SUBJECT : Hyundai ImageQuest Co., Ltd.
FCC ID: PJIL19A00000
Class Permissive Change
Orig. Grant Date : March 29, 2005

FCC ID : PJIL19A00000
Model/TYPE : B90D/L19A00000

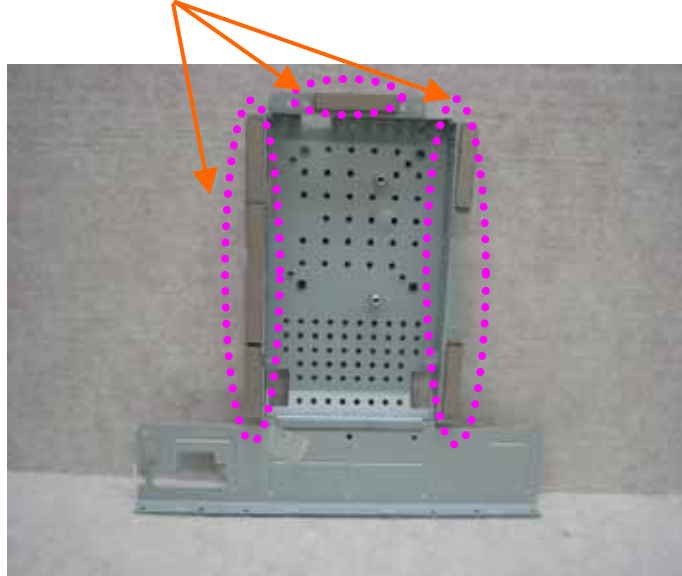
1. Attach a gasket on the main frame to contact the lcd panel

2. Attach aluminum tape on the Rear frame.
